## TRAFFIC IMPACT ASSESSMENT

PROPOSED INDUSTRIAL ESTATE

4499 – 4651 MOUNT LINDESAY HIGHWAY,

(In Response to Further Issues Dated 18<sup>th</sup> November, 2018)

FIGURE 3.1 – PROPOSED SITE PLAN

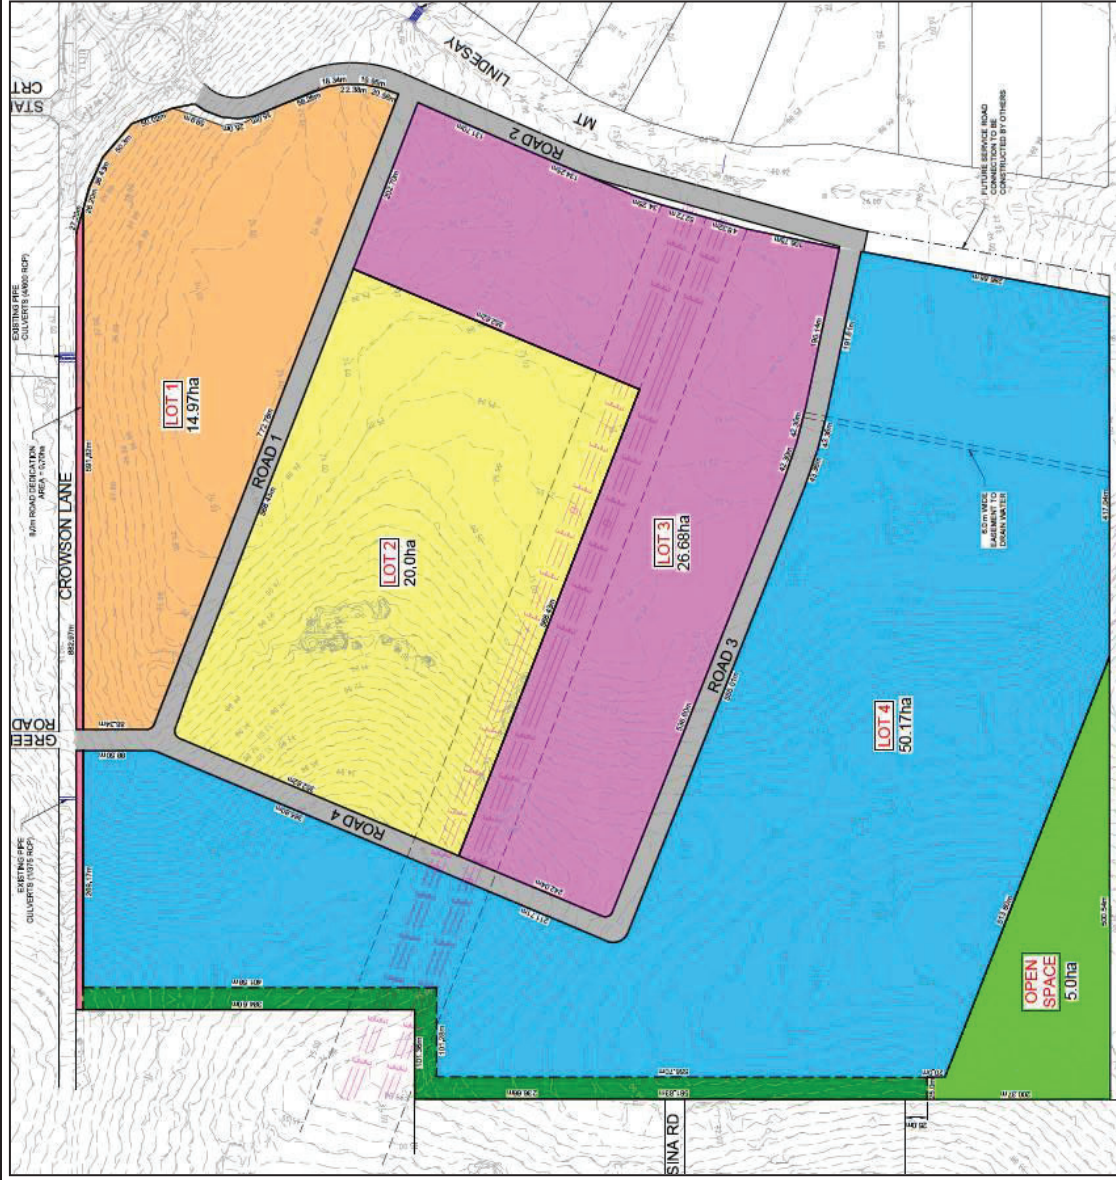
*a) EDQ is seeking a connection (link road) between the existing cul de sacs*

The proposed masterplan has been modified and no longer contains any cul-de-sac roads.

An allowance for the 8.0 metre dedication has been provided on the latest masterplan.

**FIGURE 3.2 – PROPOSED INTERSECTION WITH CROWSON LANE (INTERIM LAYOUT)**

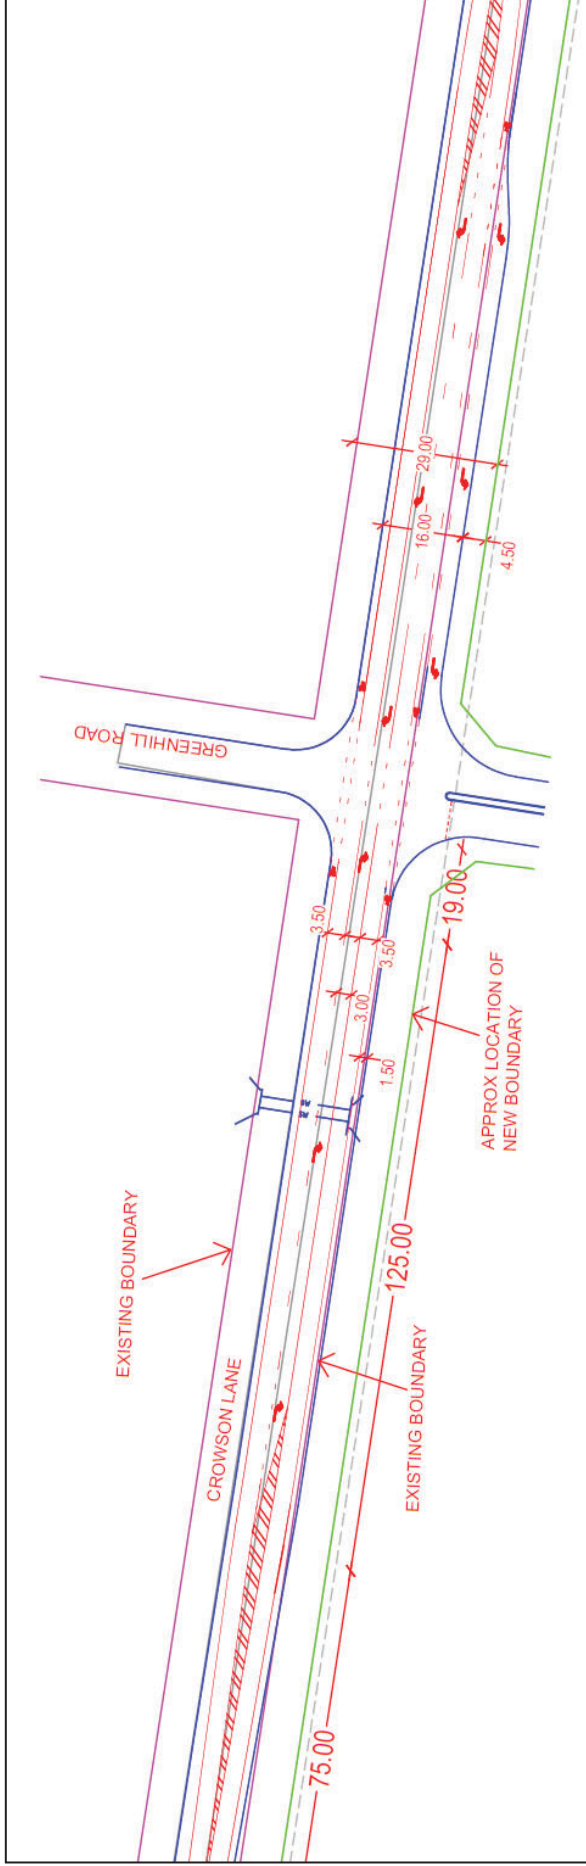
- o that an 8m dedication be shown on the subdivision plan. EDQ indicated that this Crowson Lane dedication would be considered trunk infrastructure and infrastructure credits would apply*
- o that an interim design for the intersection with Crowson Lane be allowed for in the subdivision design and shown on the plans*

Indicative plans of the interim and ultimate access arrangements are shown in Section 3.2. SIDRA modelling has been carried out for each of these scenarios. The SIDRA modelling indicates that the interim layout will function satisfactorily for a considerable period of time. The need and timing for traffic signals largely depends on future background traffic growth on Crowson Lane. It is recommended that further traffic modelling be carried out at each stage of the development to determine the required timing for signals.

The intersection on Crowson Lane will be constructed as a priority controlled junction with dedicated left and right turn lanes. An 8 metre wide land dedication will be provided along the site frontage to achieve a 29 metre wide road reserve. This will allow the Rural Arterial – Single Carriageway to be achieved.
